SB-10046779-4871SI M17 06 12
Cooling SystemsOctober 2012
Technical Service

This Service Information bulletin supersedes SI M17 06 12 **dated September 2012.**

NEW designates changes to this revision

SUBJECT**Service Action: Retrofit of the Engine Coolant Temperature Sensor****MODEL**

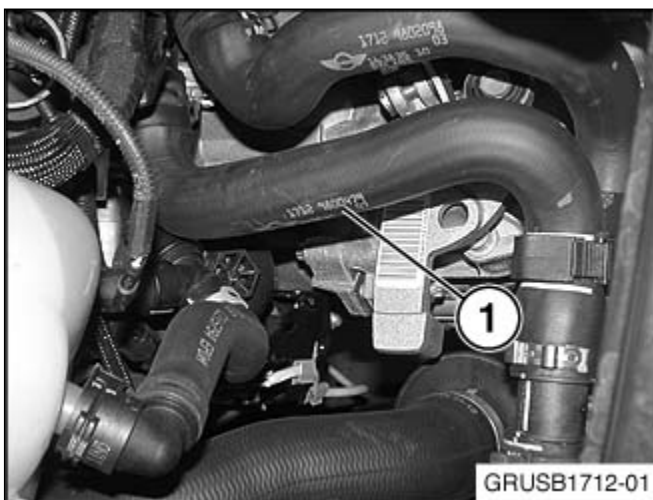
NEW Checking for the updated thermostat: The 11 53 7 534 521 thermostat has a replaceable engine temperature sensor (1).

NEW This Service Action does not apply to any N16 engine that had a thermostat replaced with P/N

11 53 7 534 521.

NEW The 11 53 7 534 521 thermostat needs to be installed in conjunction with an engine electrical wiring harness replacement.

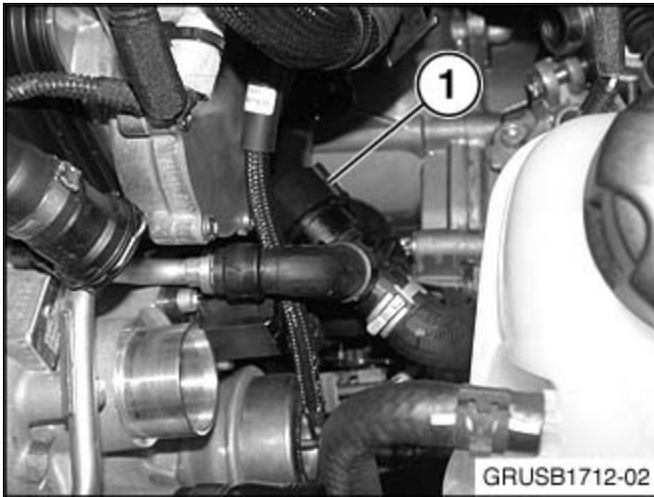
Remove the coolant hose (1). This hose will not be reused.

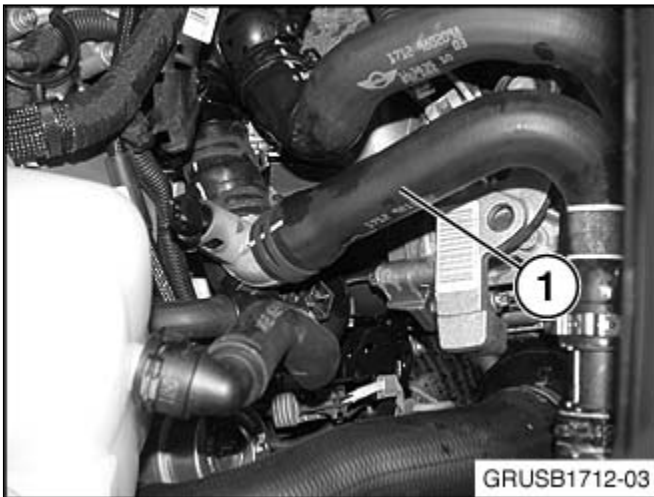
N18 engine only! Install spacer P/N 64 53 7 578 707 (1) on the coolant line as shown.

Note: The spacer needs to stay in this position when installing the new coolant hose P/N 17 12 7 647 004 (next step).

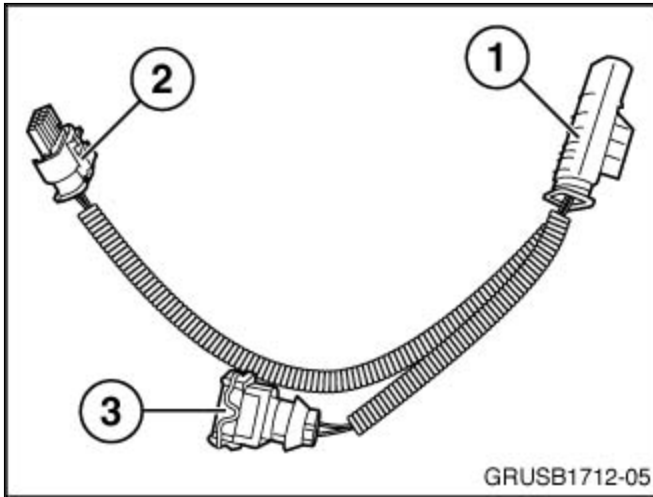
Install the new coolant hose with sensor P/N 17 12 7 647 004 (1).

Unplug connector X6279 from the engine thermostat (1).

Plug connector X6279 into the 4-pin male connector (1) of adapter harness P/N 12 51 7 647 200. Insert the 4-pin female connector (2) of the adapter harness into the engine thermostat. Plug the 2-pin female connector (3) from the adapter harness into the engine temperature sensor of hose P/N 17 12 7 647 004.
